Dresden Station Unit 3

Proposed Changes to Appendix A  
Technical Specifications to Operating  
License DPR-19

Design Specification  
for the  
Control Rod Drive  
Scram Discharge System Modification

Attachment B

Figure I

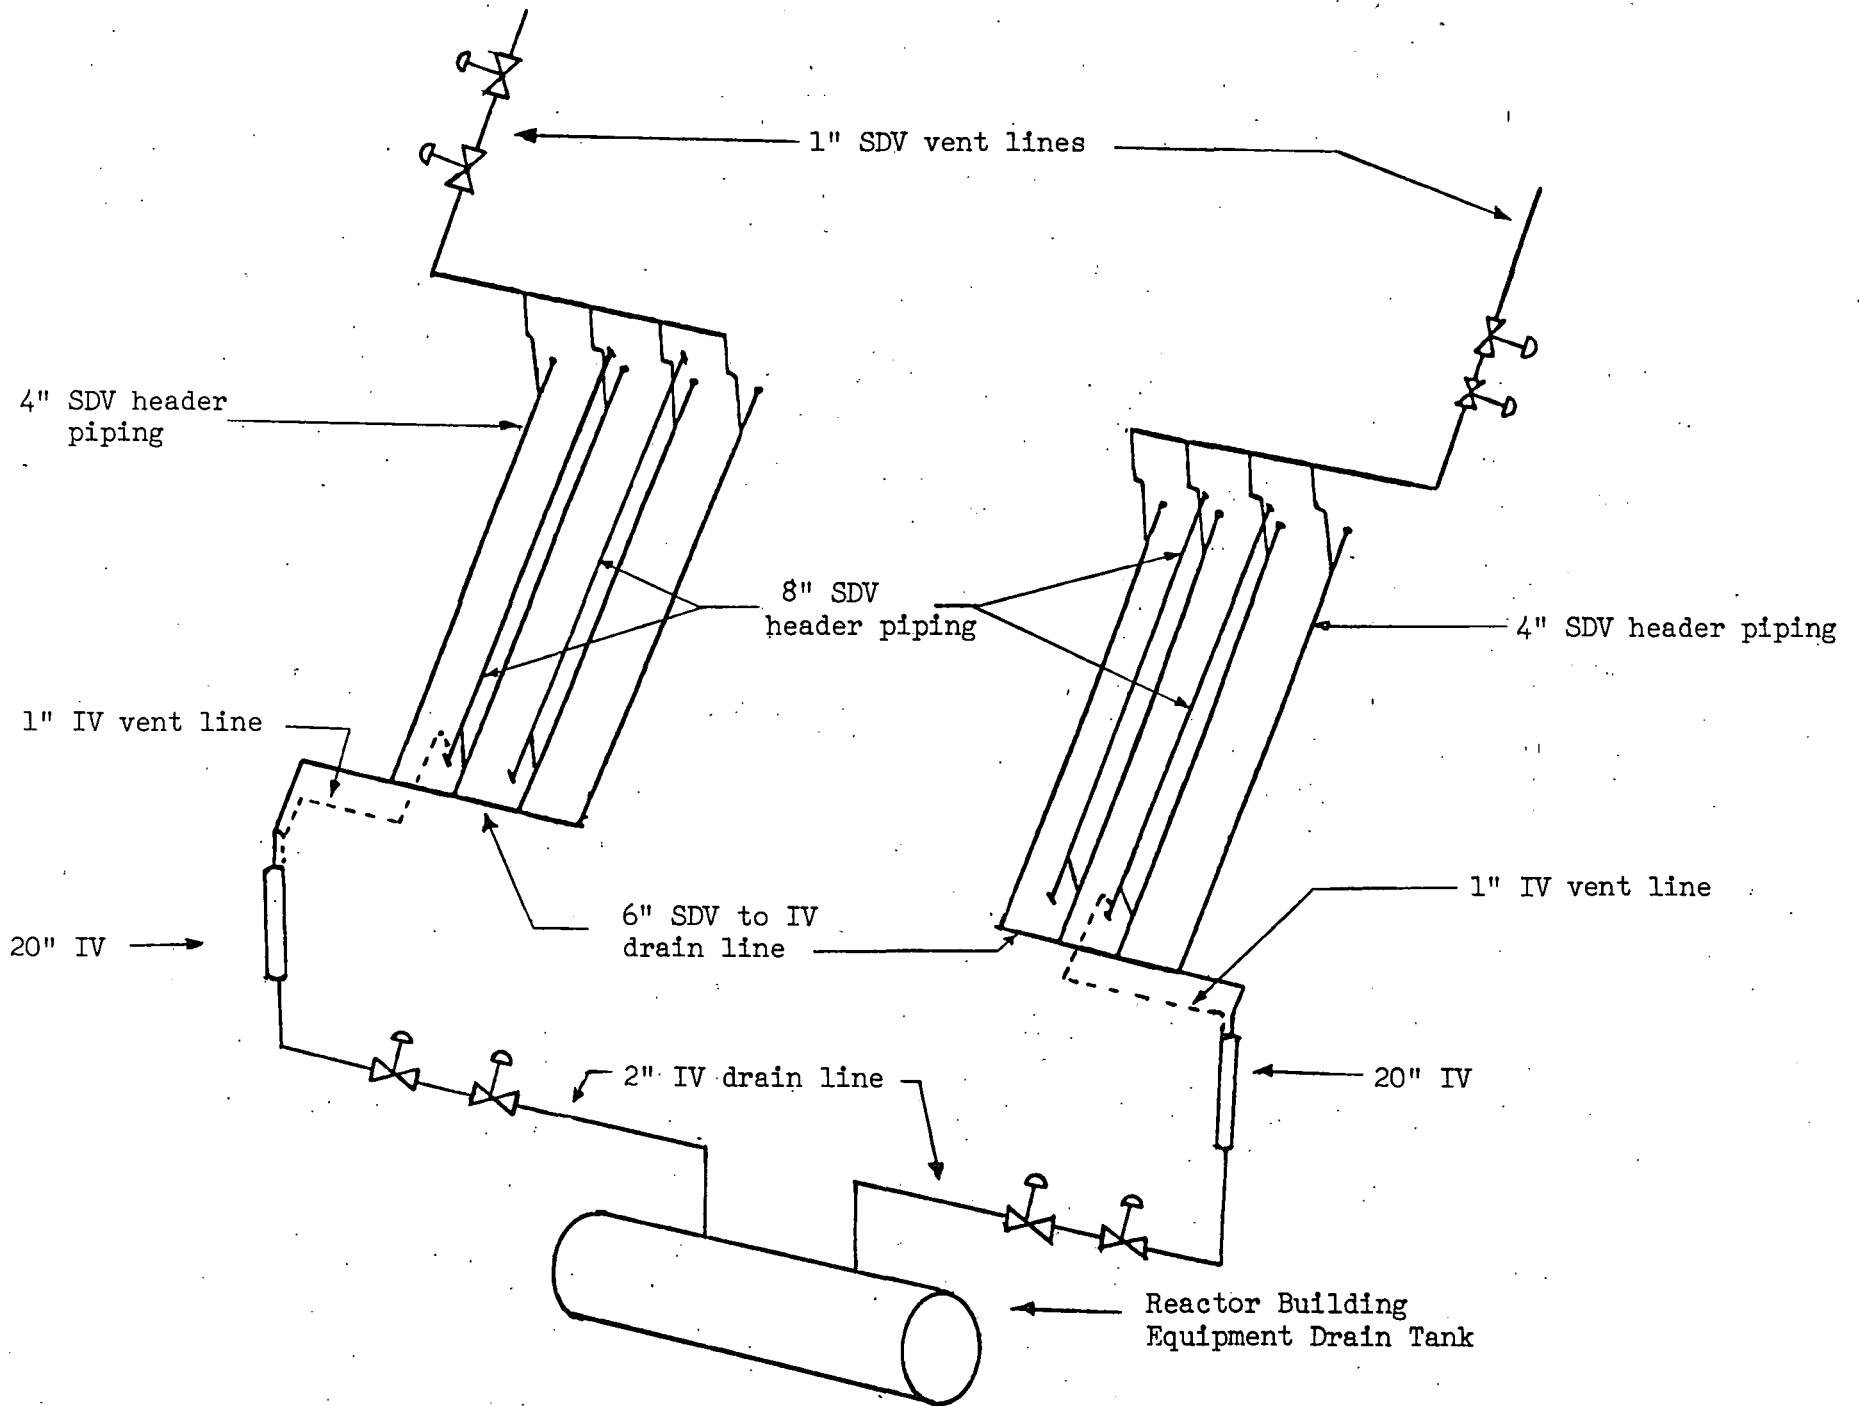
The new instrumentation design incorporates a 1 out of 2 twice logic scheme with each instrument volume having the ability to independently scram the reactor. See figure 1 for the scram signal initiation logic. Single failure of any one instrument on each instrument volume will not impair the ability to safely shutdown the reactor.

Figure 2

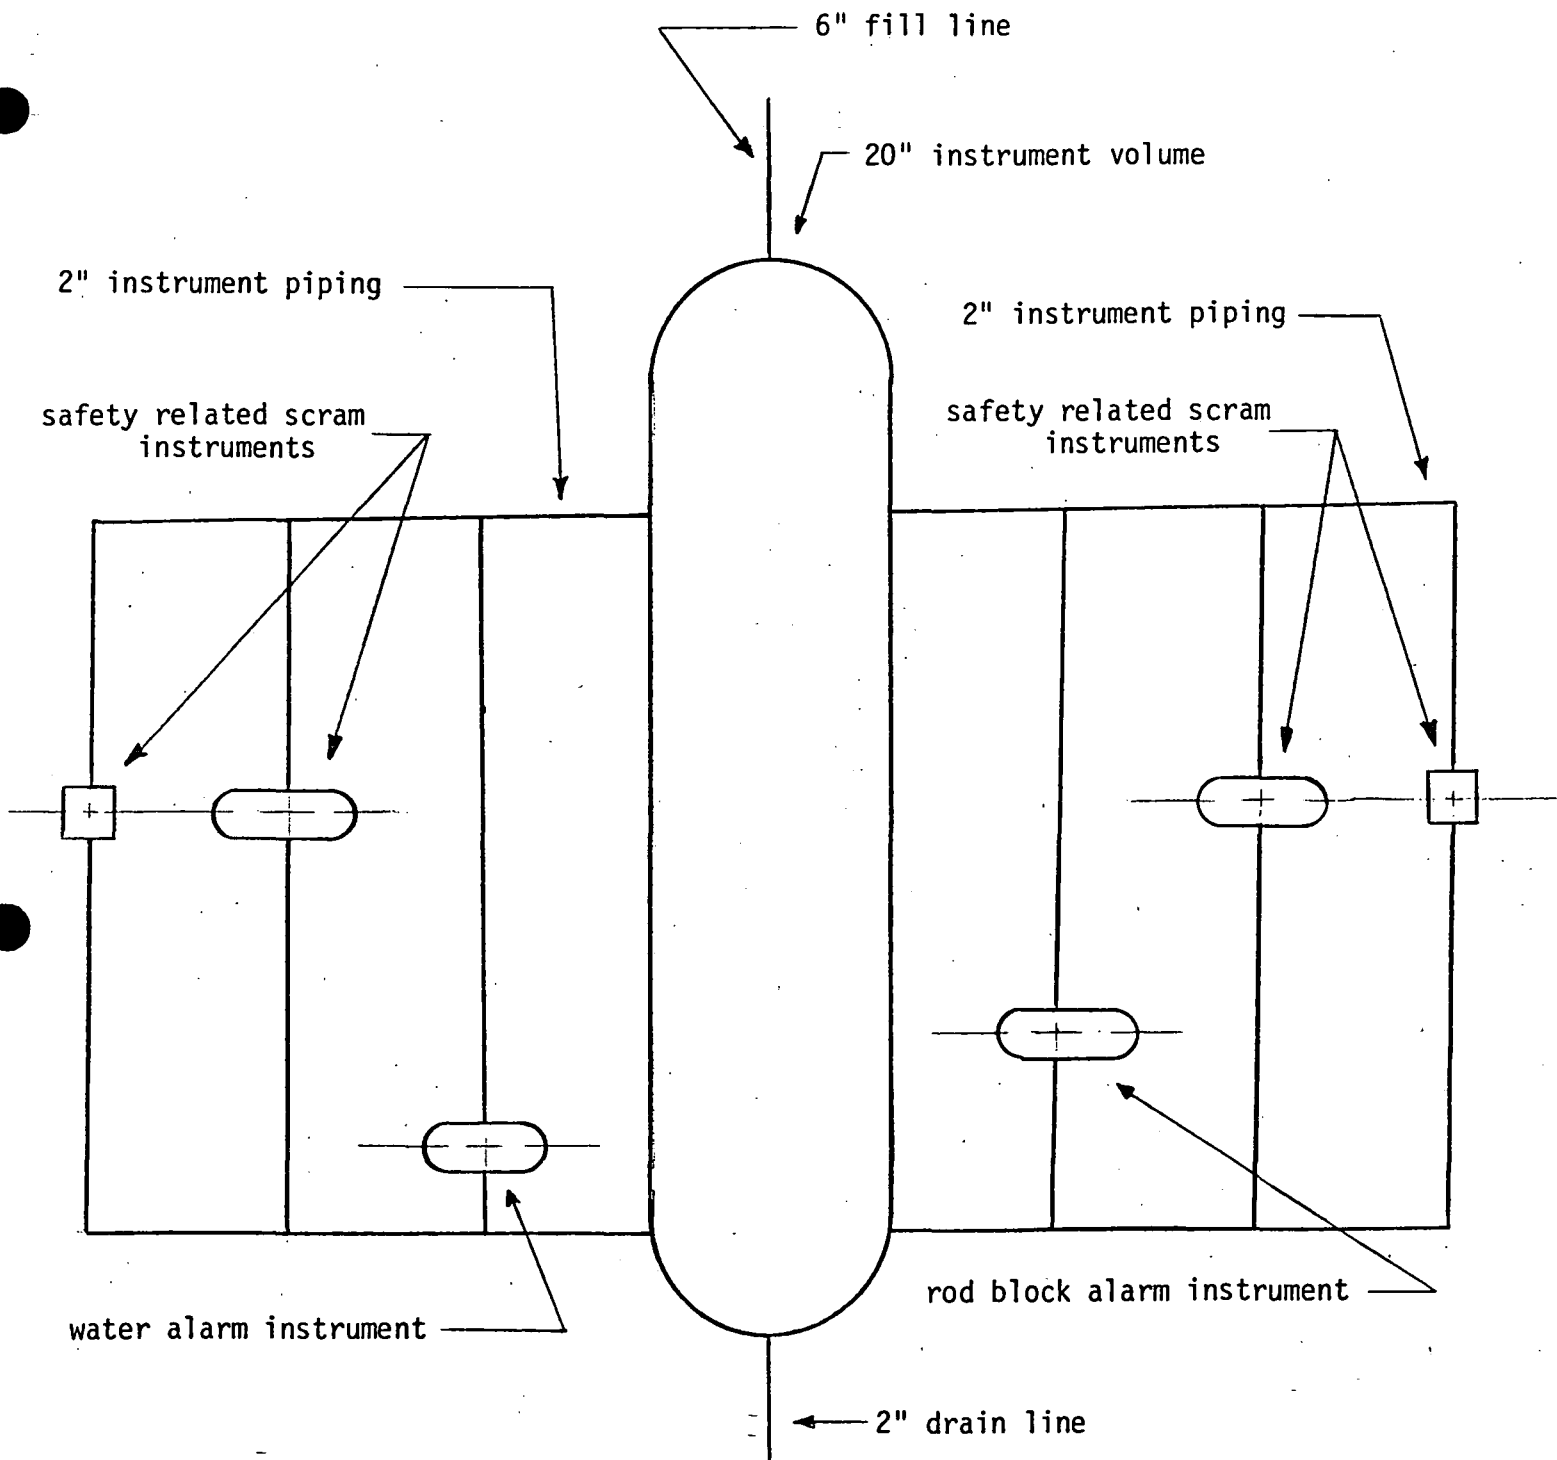
The scram discharge headers have been sized to receive approximately 4.5 gallons per drive which is in excess of the GE OER-54 criteria. Each instrument volume is hydraulically coupled to the low point of the SDV piping. See figure 2. Each 20" diameter instrument volume is attached to the 4" SDV header piping with 6" schedule 80 pipe. The system has been designed to automatically scram without the need for vents or drains while a maximum inleakage of 5 gpm per drive occurs from each control rod simultaneously. The system will automatically scram before sufficient volume is lost in the SDV and IV piping. An analysis verifying this performance has been made.

All instruments installed on each instrument volume are attached to 2" instrument line piping rather than the body of the instrument volume itself. The 2" instrument lines are connected to the IV body and are independent of the instrument volume drain and fill lines. See figure 3. This type of installation protects the instruments from water hammer forces produced during the scram discharge and venturi effects that might be caused by the IV drain and fill lines. Because of the new instrumentation design, functional testing of water level instrumentation will not be made after every scram.

Each instrument volume has two instrument lines (see figure 3) with sufficient instrumentation on each line to automatically scram the reactor. Single failure of any safety related instrument or the plugging of an instrument line will not prevent detection of water accumulation and a resulting scram when necessary.
